## ADDENDUM NO. 2 TO PROJECT NO. Q1878

CONSTRUCTION WORK  
PROVIDE EGRESS PLATFORM  
RIVERFRONT PUMPING STATION  
1 QUAY STREET  
ALBANY, NY 12242-0001

November 12, 2024

SHEET TITLE:	
<b>SITE PLAN</b>	
DRAWING NUMBER:	
<b>C-100</b>	
SHEET	2 OF 11

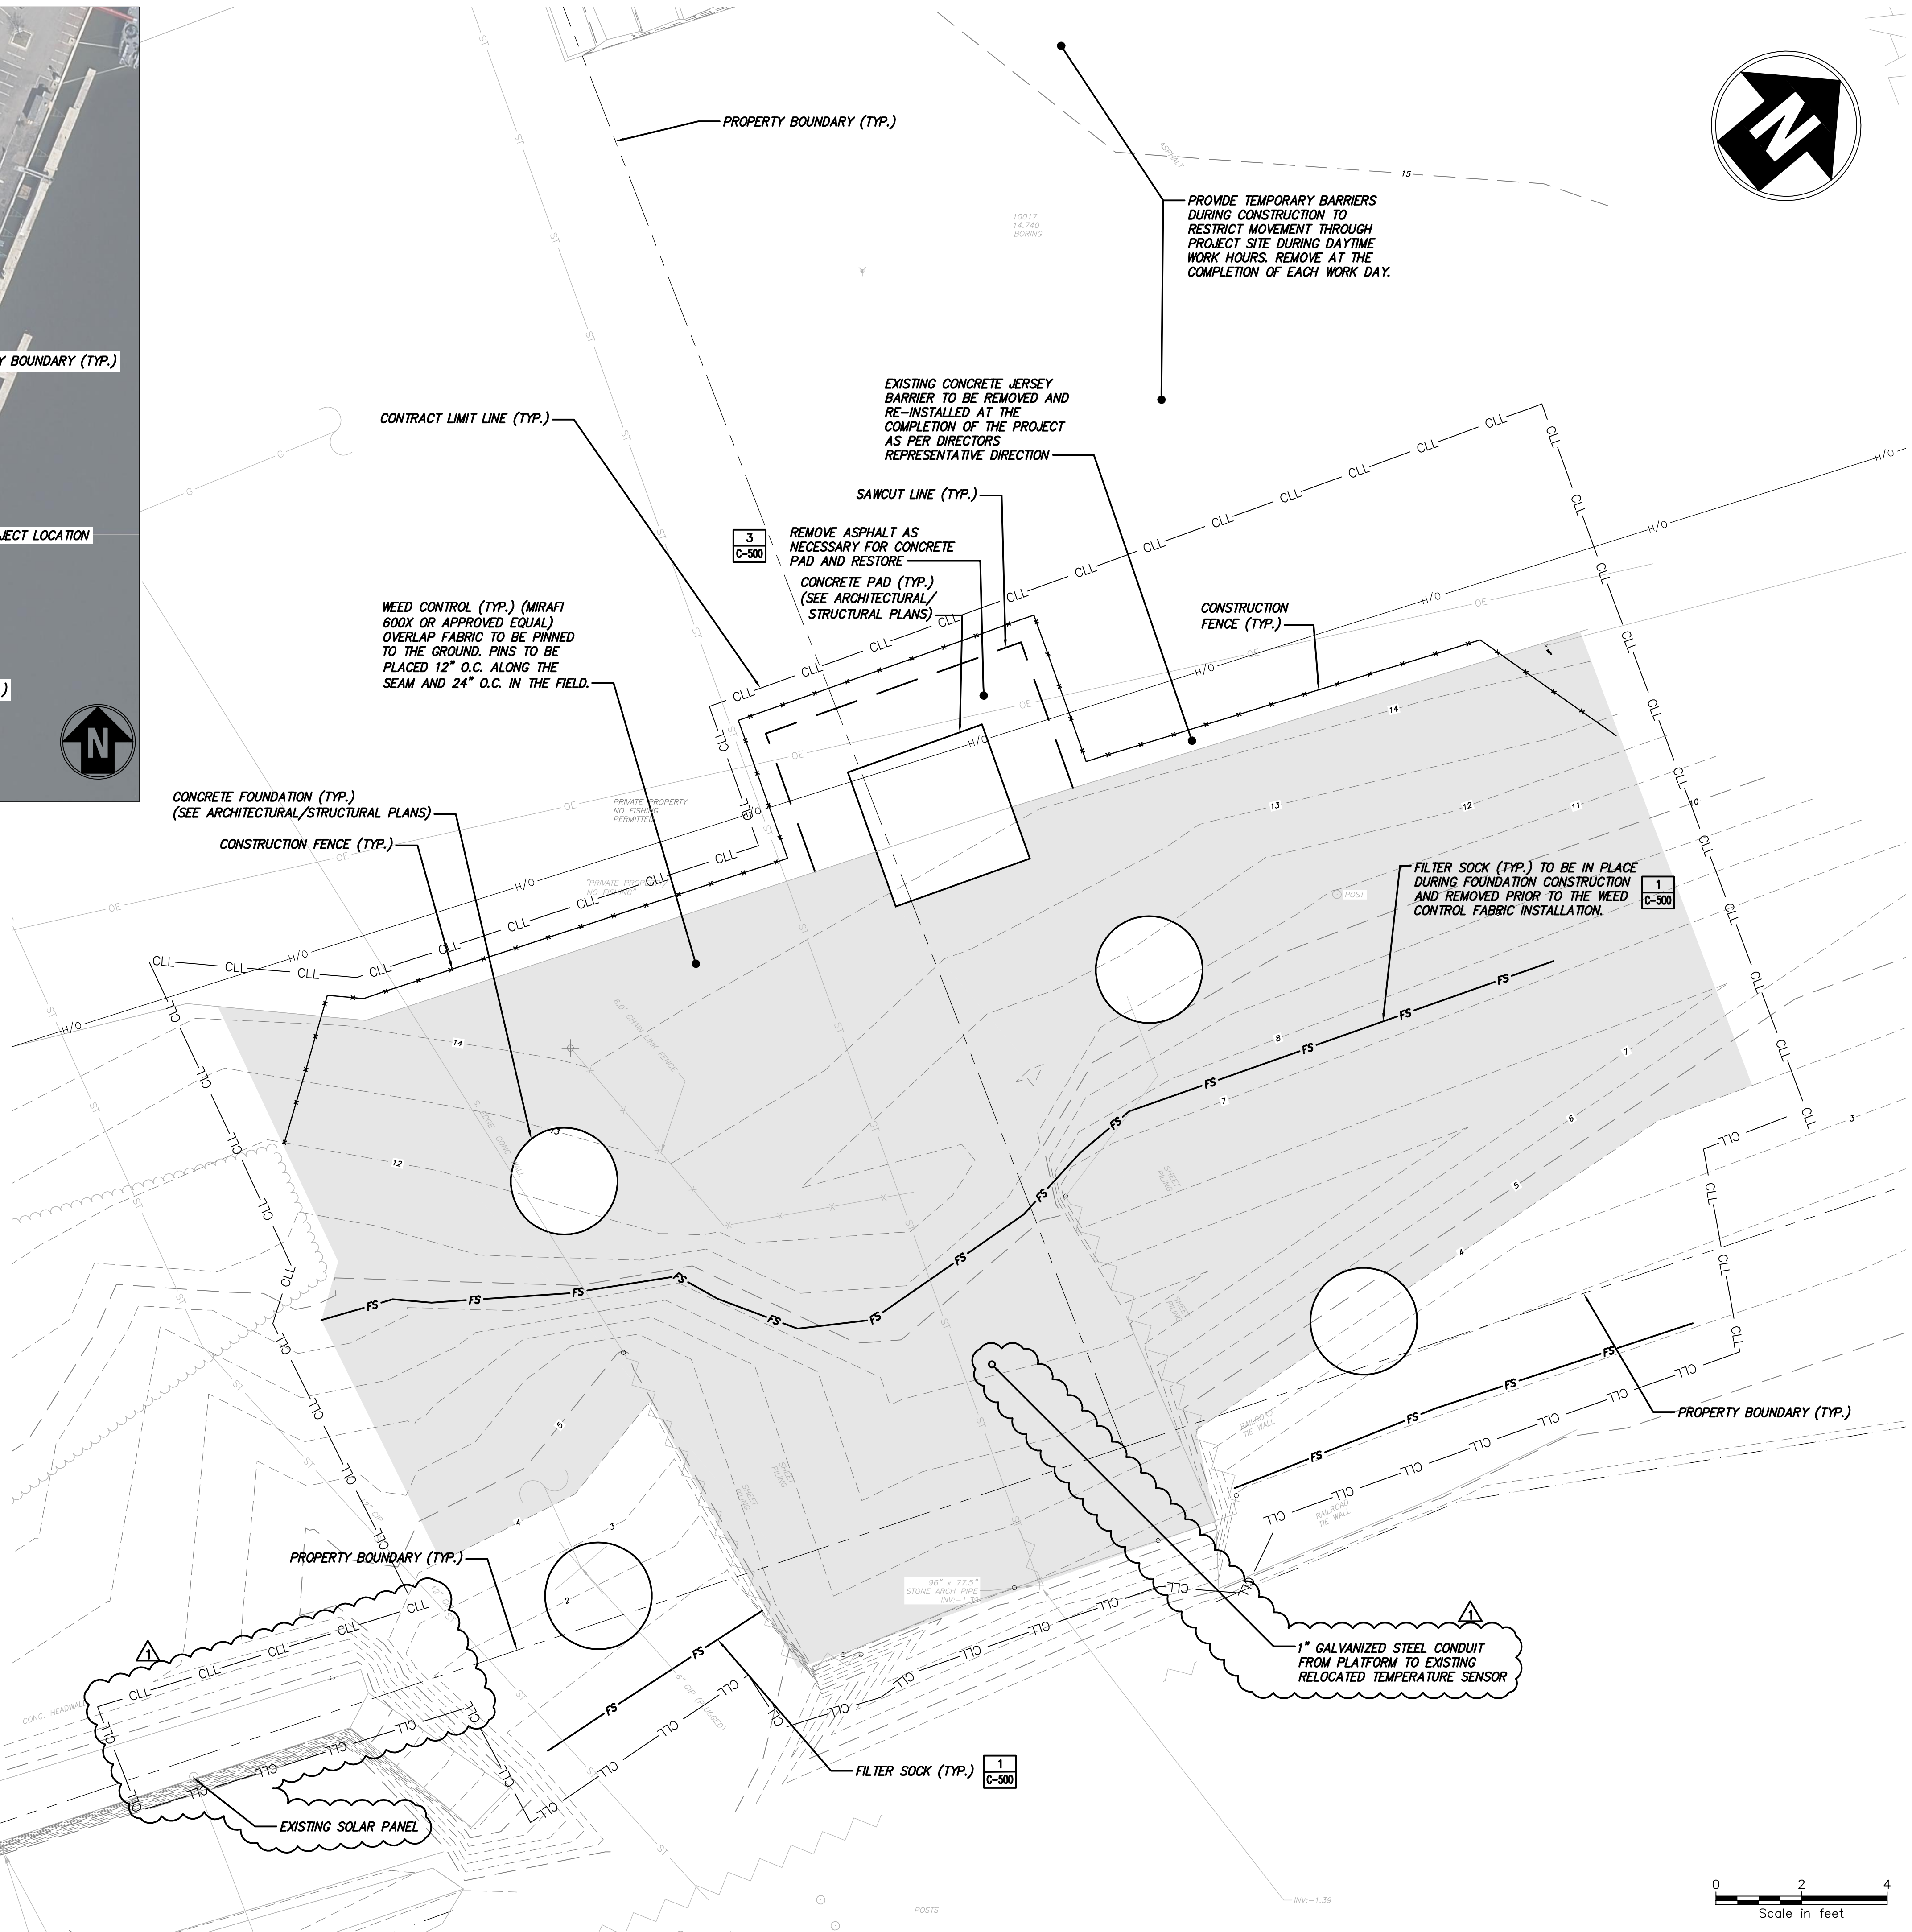
3. Revised Drawing: Drawing No. C-100:
  - a. Drawing No. C-100 noted “11/07/2024 CLL AND CONDUIT ADJ” accompanies this Addendum and supersedes the same numbered originally issued drawing.

MARK	DATE	DESCRIPTION
△	11/07/2024	CLL AND CONDUIT ADJ
